DATE: 10.23.2019
TO: ProTrak
FROM: Bill McDow
Transportation Planning

■ **WILMINGTON TREATMENT CENTER [TRC Plan Review #2] Landscape**

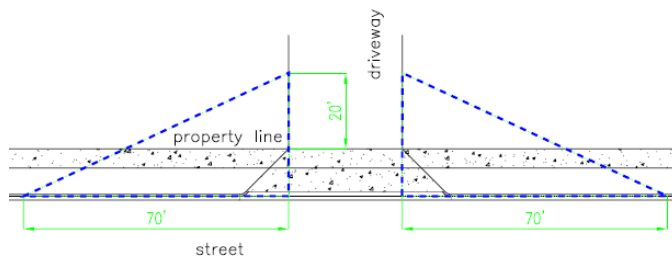
1. The proposed site plan appears to have existing trees or vegetation located within the driveway area, Reflections Road and the area where the 20'X 70' Sight Distance Triangles should be located. Please verify the landscape layer is properly shown on this plan.
2. Show and apply the City's 20'x70' sight distance triangle at each driveway and the City's 46'x46' sight distance triangle at each street corner intersection on the site plan and landscaping plan. [Sec.18-529(c)(3)CofW LDC] Add a note indicating that all proposed vegetation within sight triangles shall not interfere with clear visual sight lines from 30"-10'. [Sec.18-566 CofW LDC]

Original Sidewalk and Painted Crosswalks

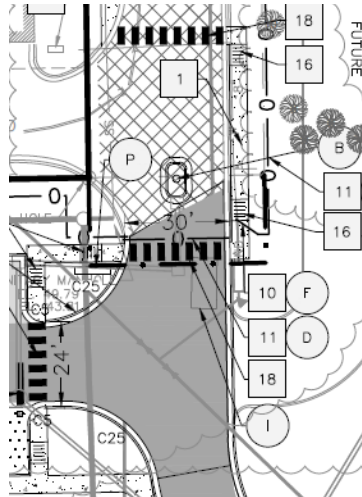
3. The plans do not show the western side of the Reflections Loop.
4. Show the location of sidewalks and street trees on the landscape plan.
5. The proposed dumpster location will be located within the 20'X70' Sight Distance Triangle for the new parking lot and driveway area. Please revise.
6. The plan does not show the sidewalk that was provided for the original Wilmington Treatment Center project and first two Dormitory Buildings. Sidewalk was approved for the North East portion of Reflections Loop and the connection to the Wilmington Fire Department drive aisle.
